PROPOSED ESTABLISHMENT OF THE ANDERSON-DINALEDI 400kV TRANSMISSION LINE BETWEEN THE PROPOSED ANDERSON SUBSTATION AND DINALEDI SUBSTATION, NORTHWEST AND GAUTEHNGE PROVINCES. ADDENDUM 1.

I-scape was appointed by Nemai Consulting to review the Visual Impact Assessment report that was compiled by Axis Landscape Architecture CC on *the Proposed Establishment of the Anderson* – *Dinaledi 400kV Transmission line between the proposed new Anderson Substation and the Dinaledi Substation in the North West and Gauteng Provinces* (Axis, 2011¹).

Project Name: Anderson – Dinaledi 400kV Transmission line (Addendum 1) Ref no: V12_007

Figure 1: New location of Anderson Substation site

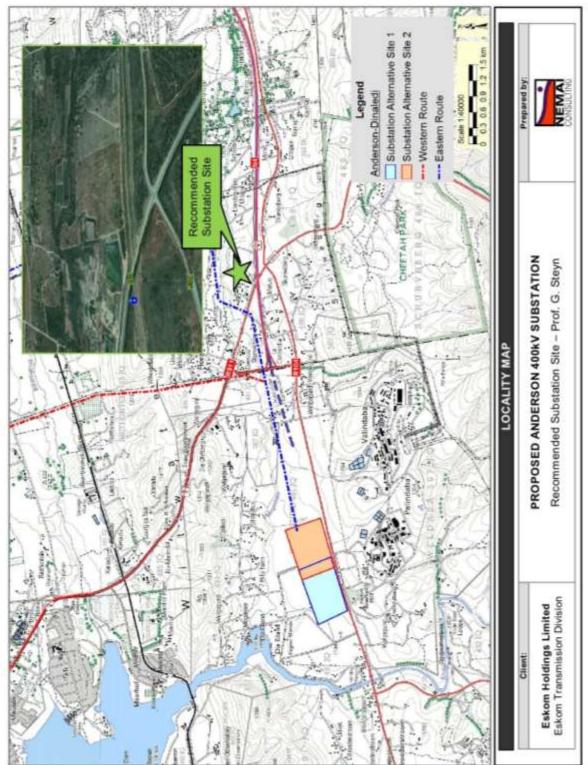
Two sites were originally identified for the location of the Anderson Substation. Site 1 was located on Portion 82 of the Farm Weldaba 567JQ and Site 2 was located on Portion 82 of Farm Weldaba 567 JQ, Portion 65 of Farm Weldaba 491 JQ and Portion 25 of Farm Weldaba 491 JQ. The location for the proposed substation was later changed to a site more to the east of the original sites on Portion 82 of the Farm Schurveberg 488 JQ (See Figure 1). This resulted in a change in the alignment of the proposed Anderson – Dinaledi 400kV Transmission line.

The transmission line routes that are affected by the change in substation site is the routes referred to as the Eastern and Western Routes. Both these routes have their origin at the previous Anderson Substation site and are now originating approximately 5 km east at the new Anderson Substation site.
